TORONTO STAFF REPORT

Subject: Request for Direction Report
Application to Amend the Official Plan and Zoning By-law
04 190410 NNY 16 OZ
Site Plan Control Application 05 200330 NNY 16 SA
Applicant: Goodmans LLP
Architect: Turner Fleischer Architects Inc.
1705, 1717, 1719, 1743 and 1745 Avenue Road
Ward 16 - Eglinton-Lawrence

1705-1745 Avenue Road

Sections

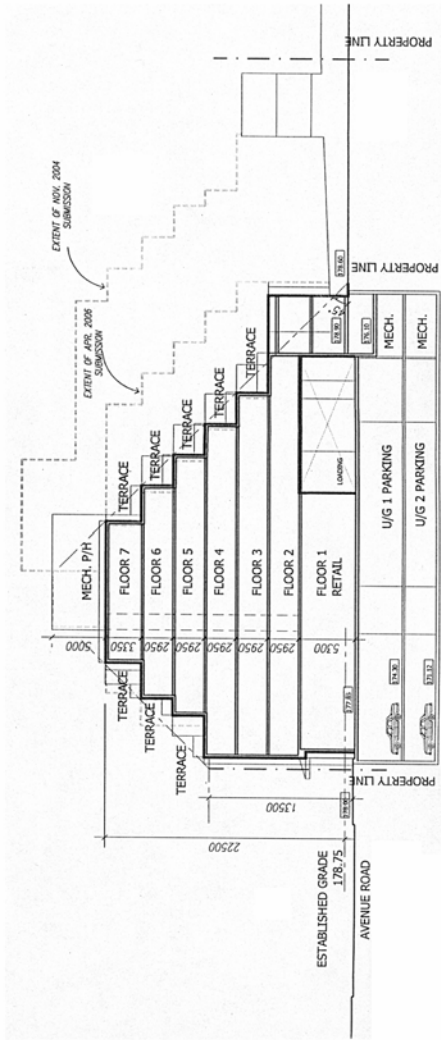
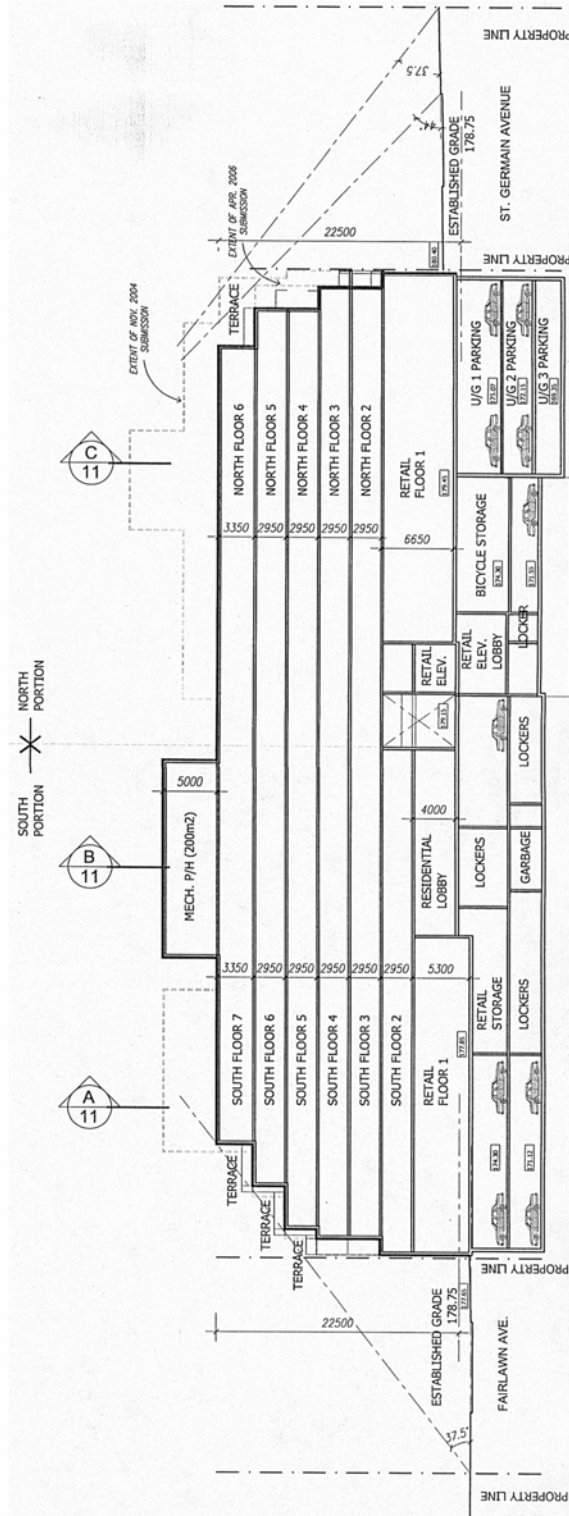
The Official Plan states that the height of new buildings in ACA areas shall generally not exceed one-half of the width of the planned right-of-way of the arterial road. The proposed height of 22.5 metres along the Avenue Road frontage exceeds one-half the planned 27-metre width of the Avenue Road right-of-way (i.e., 13.5 metres). However, the building is 13.5 metres in height along the Avenue Road frontage and the upper storeys step back under a 45-degree angular plane measured from this base condition, reducing the physical and visual impacts from the street. This is illustrated in the Section drawings included as Attachment 4.
